Service Bulletin #264

SB-264
(01806)
ECN_8226

Ford F-250/F-350/F-450 (Single and Dual Rear Wheel) 57396 and 88396 Four-Wheel-Drive Underbracket Redesign

Which Design Do You Have?

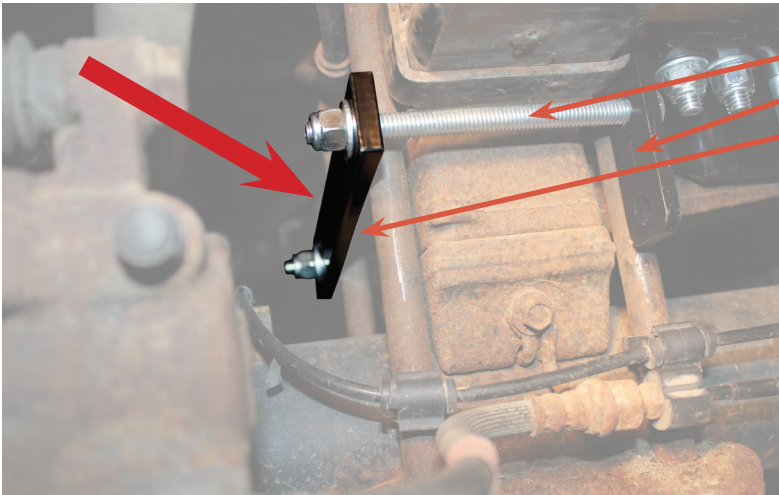
Background: The bottom bracket for this kit was redesigned to reduce complexity and installation time.

If the air spring's bottom plate is attached by two bolts holding a retainer plate alongside the vehicle's leaf spring mount, it is the 1st-generation design.

If the bottom plate is attached by a U-bolt, it is the second-generation design.
